STRUCTURAL ADDENDUM #1

Project Name: Hampton Manor (25 Baker Hill Boulevard) – Stouffville
Project Number: 20140490

June 15, 2017

S1-02A

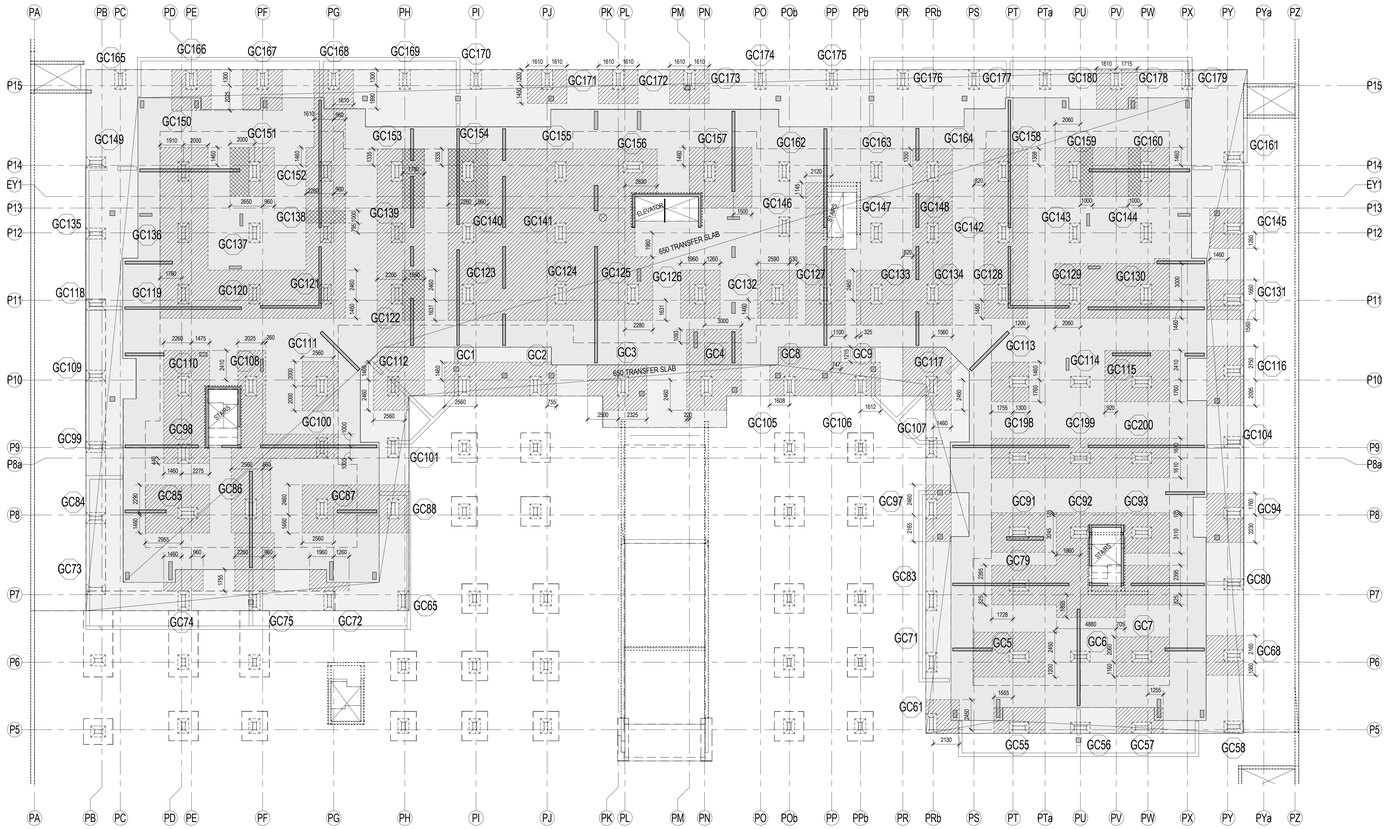
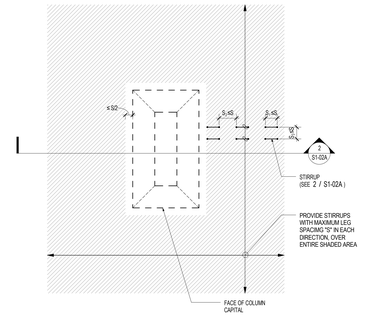
.1 Revise reinforcement for slab at Ground floor as indicated on Drawing S1-02.
.2 Revise concrete strength for transfer slab as noted on Drawing S1-02 and add shear reinforcement as shown on Drawing S1-02A.
.3 Revise Ground Floor sections as indicated on drawing S5-01.

W1 WALL ELEVATION
S3-02 1 : 100

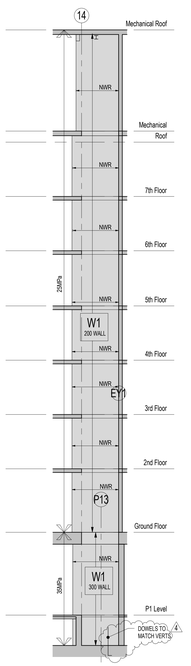
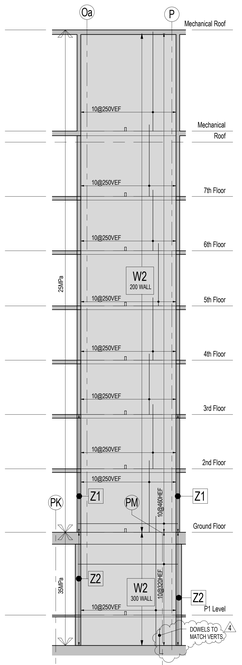
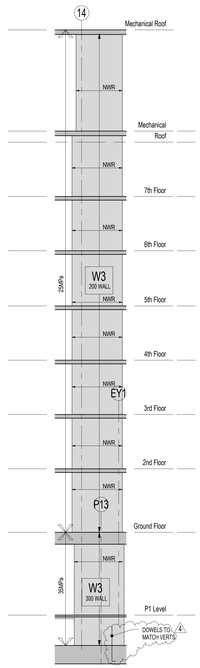
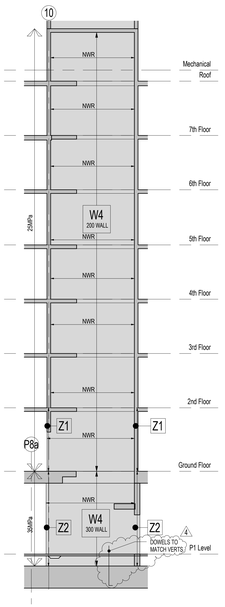
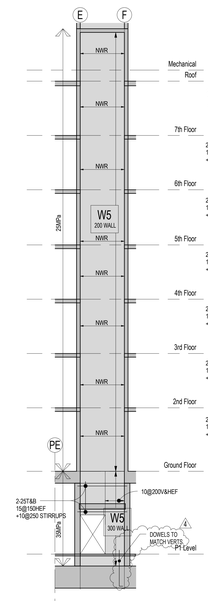
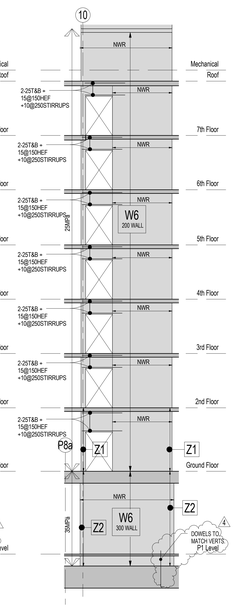
.1 Revise thickness and reinforcement of columns and walls as noted.
.2 Revise shear wall openings as indicated.

FOUNDATION SECTIONS

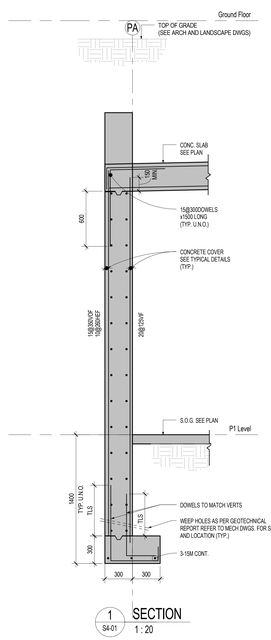
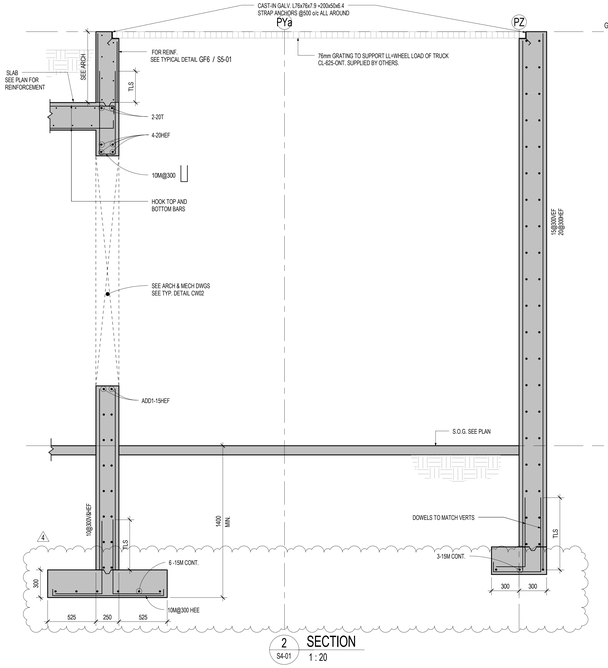
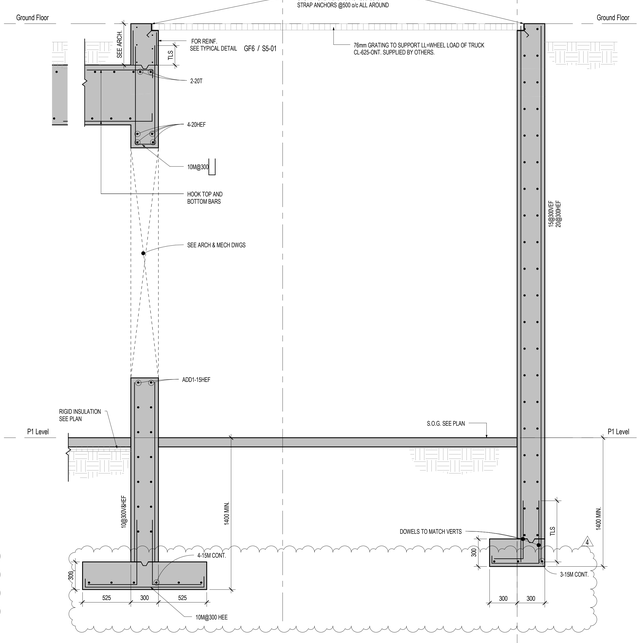
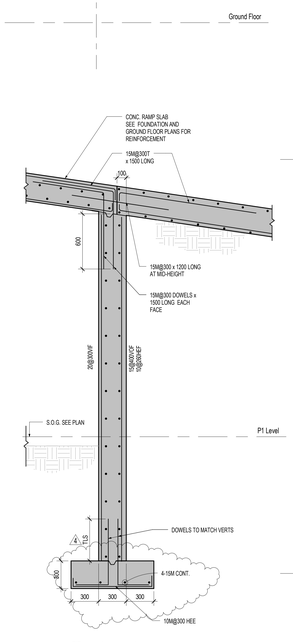
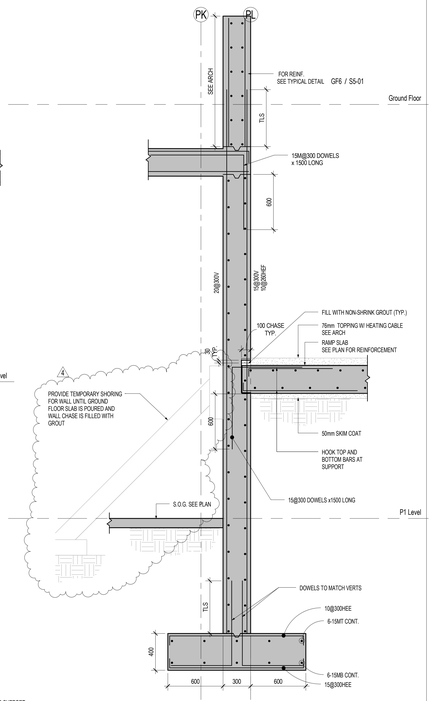
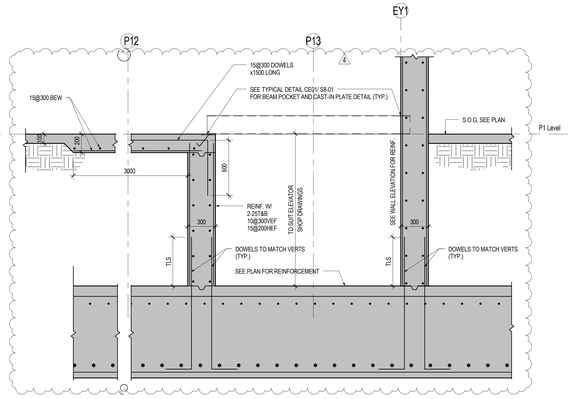
.1 Revise footings, columns, foundation sections and stair sections as indicated.
